# **Annual Monitoring Report**

Monitoring Year 3 of 7

Pee Dee Stream Restoration Project

RE: Pee Dee Stream Restoration Site: MY3 Monitoring Report (NCDMS ID 95350)

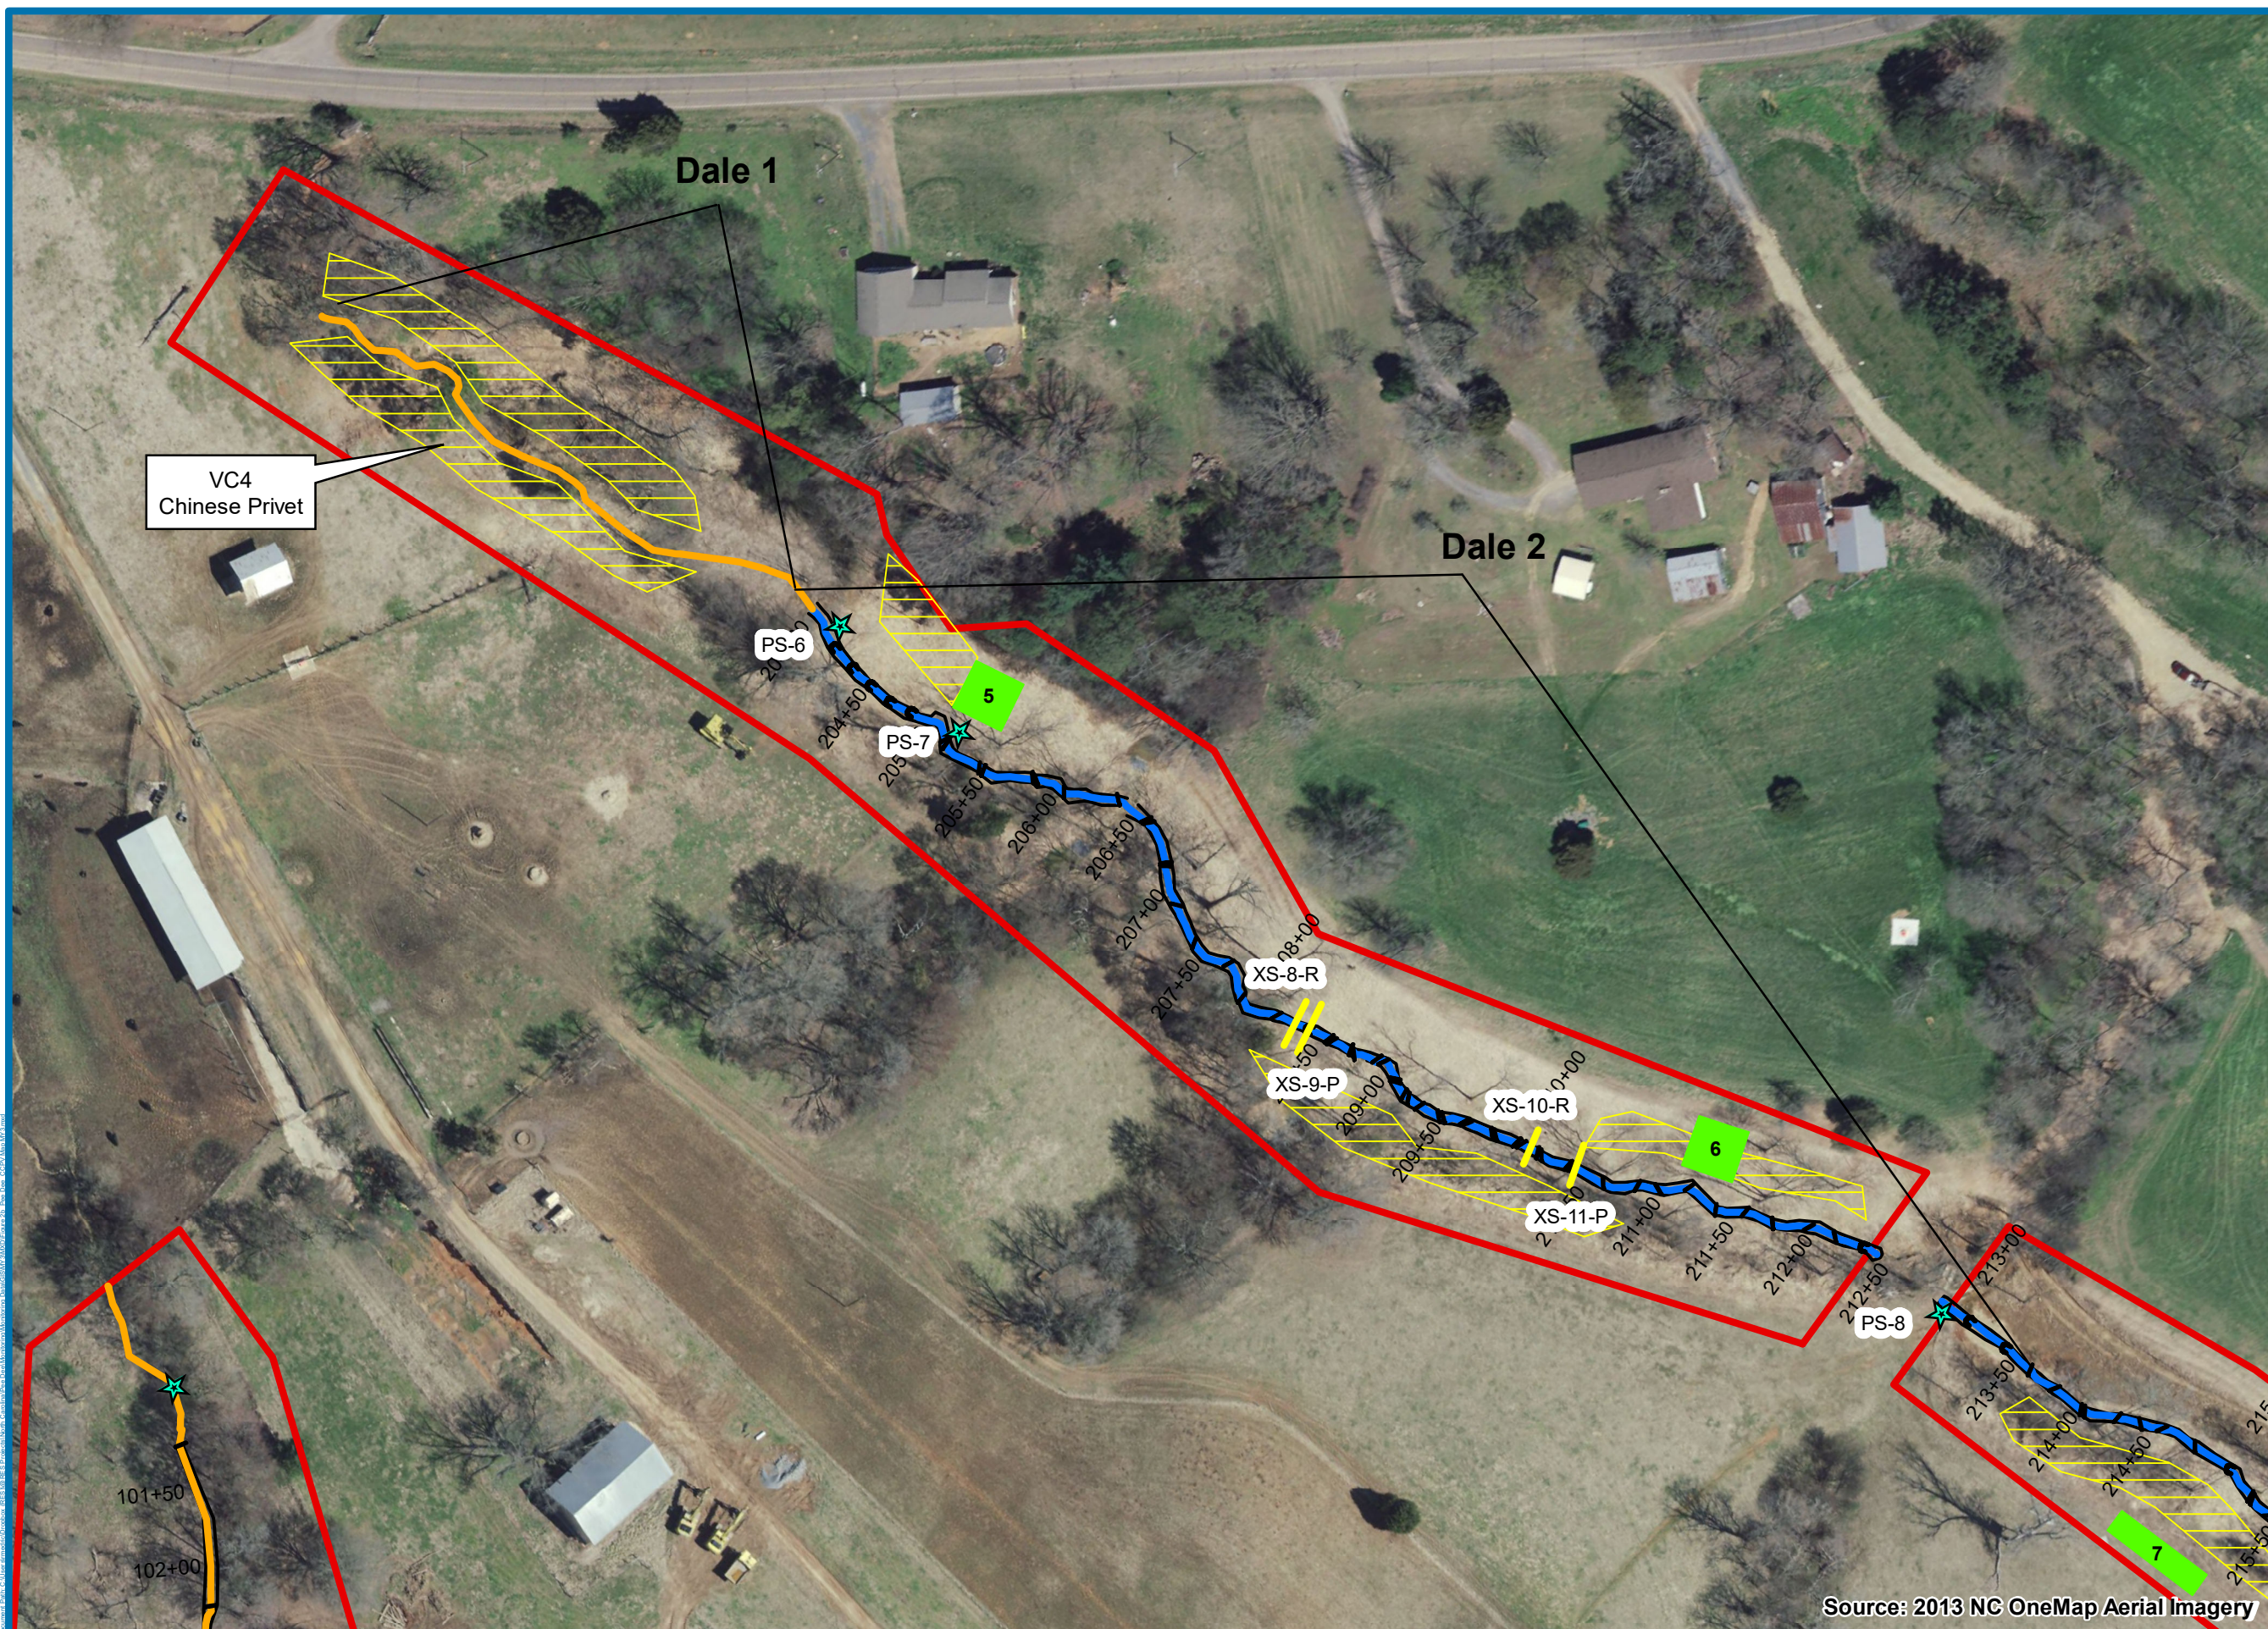
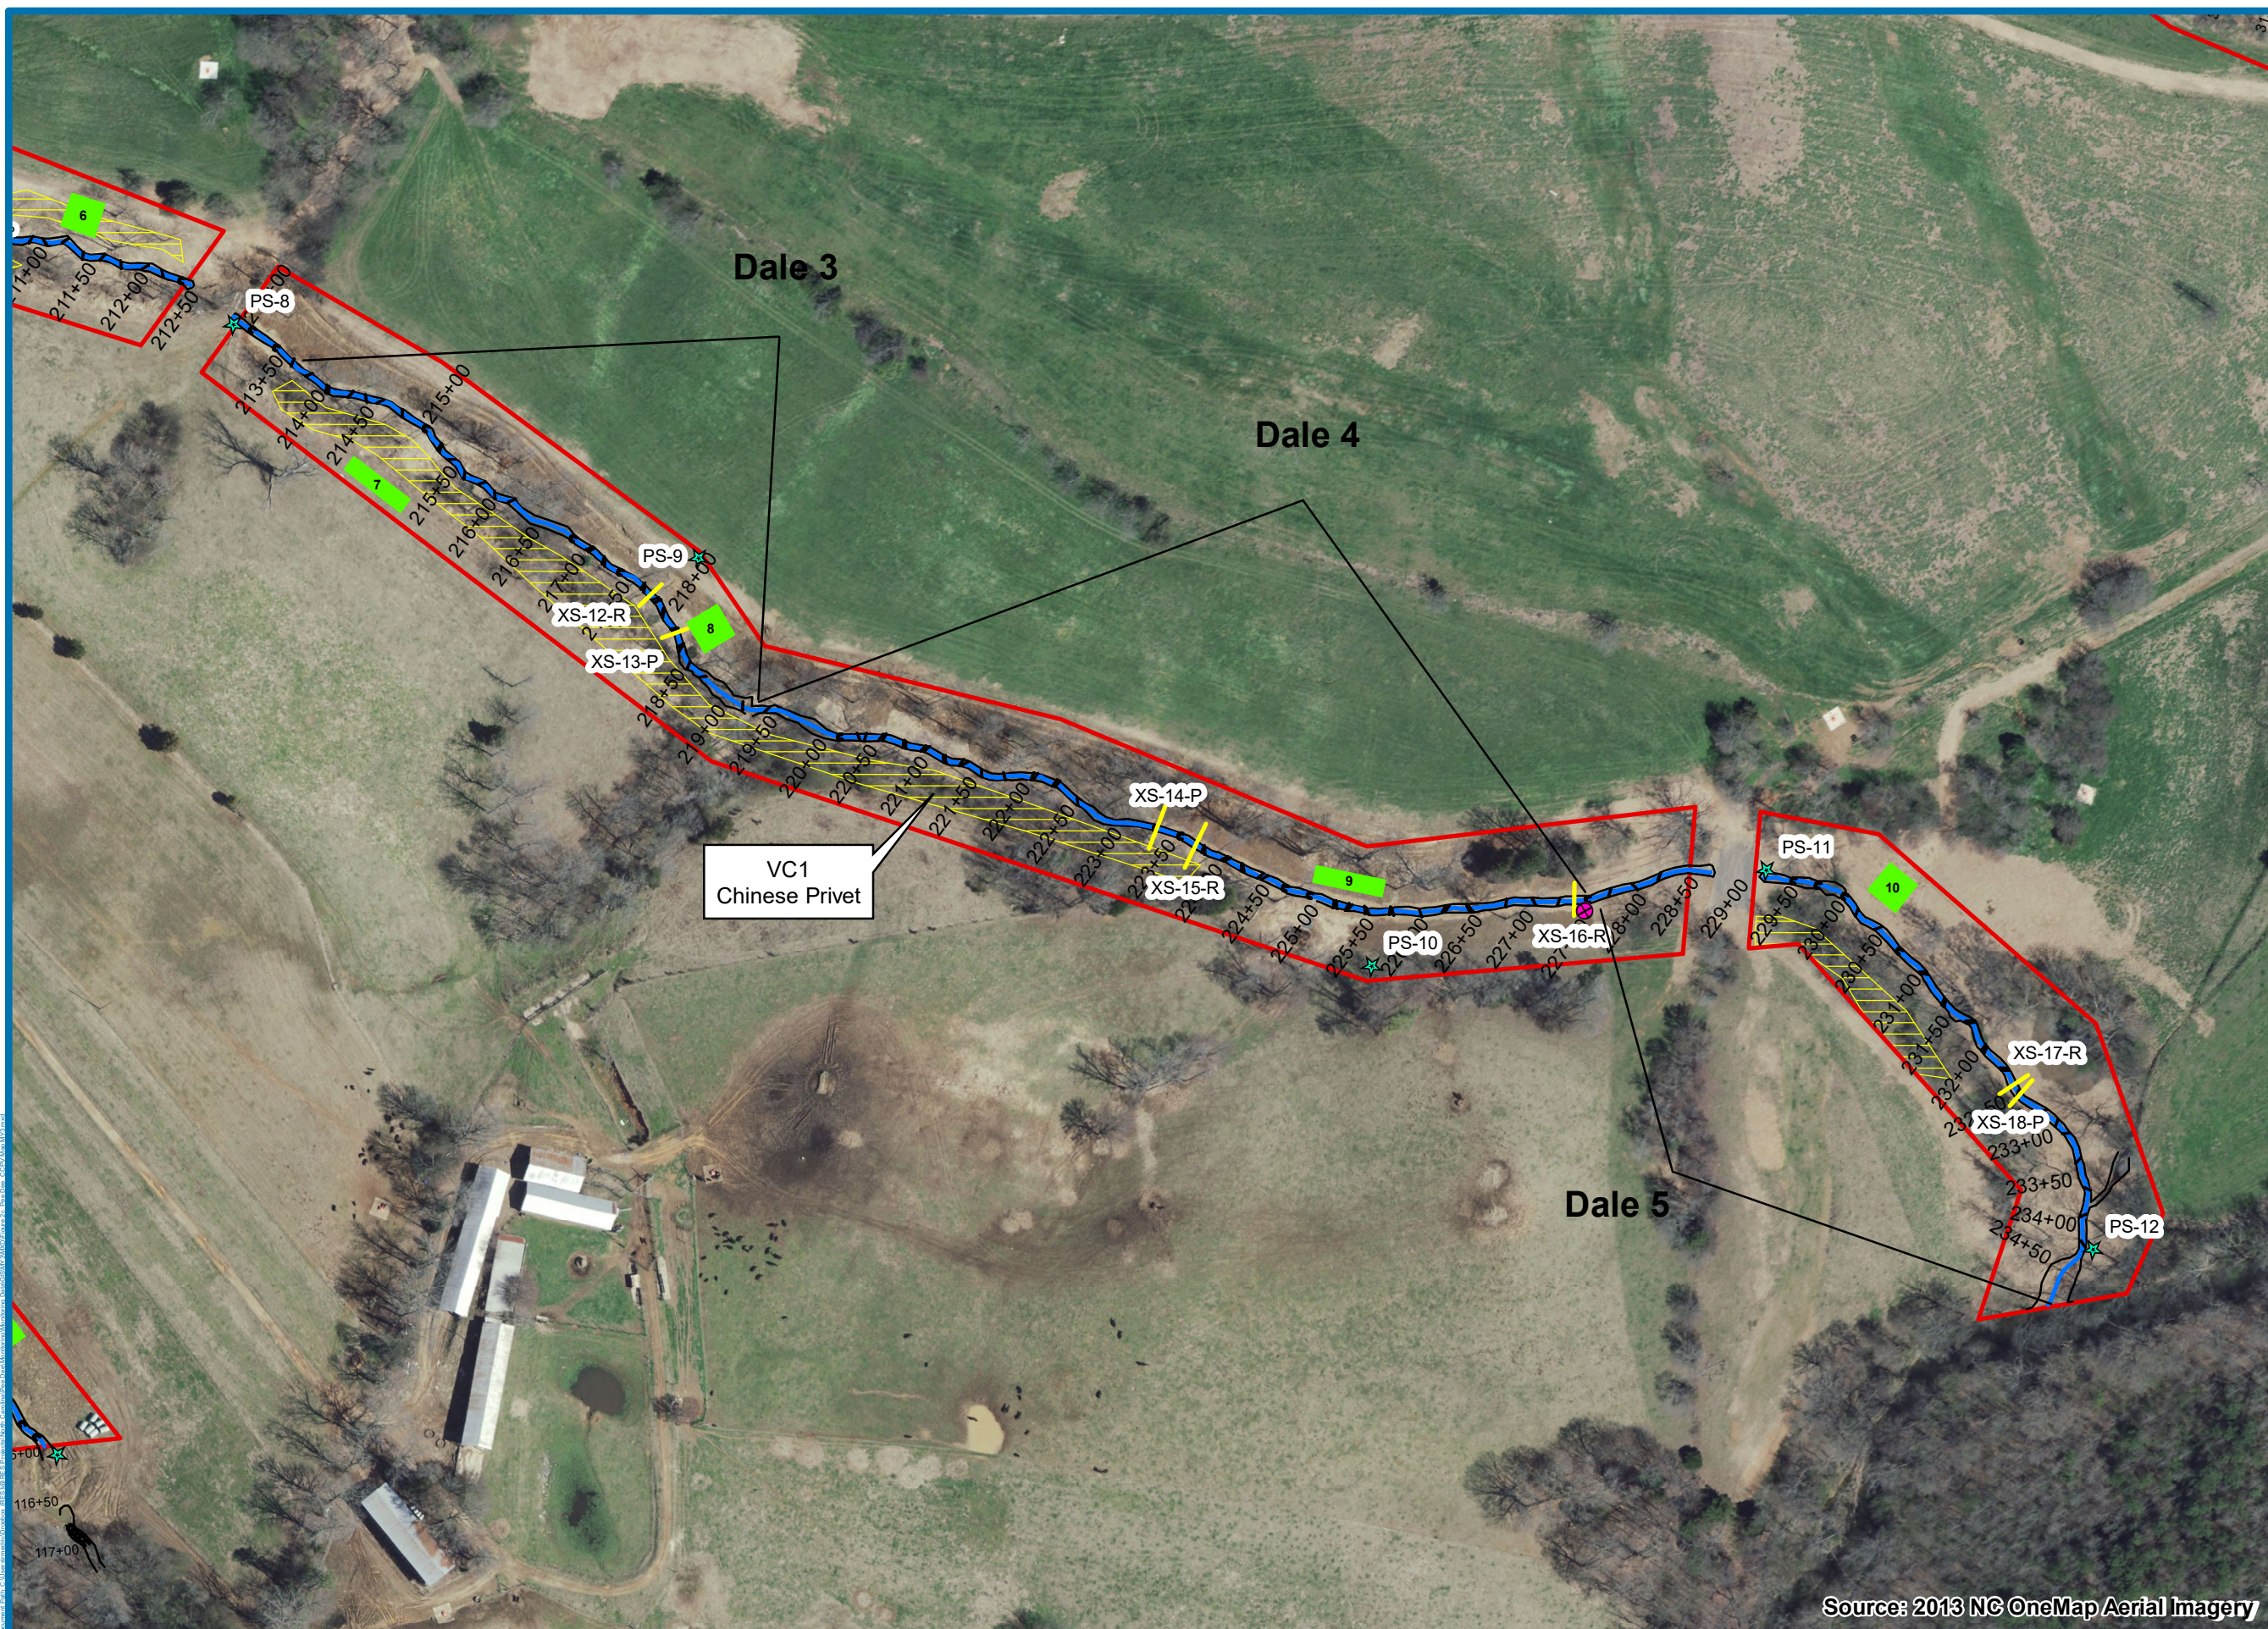
When CCPV is folded out, the Jerry Branch map appears upside down; also cross section tables, etc. Even though this is not a problem in the digital PDF, sheets should not appear upside down when the hard copy report is read.

It would be helpful to show major station breaks on the CCPVs.

Landscape printing issues have been corrected in the Final Report.

Done.
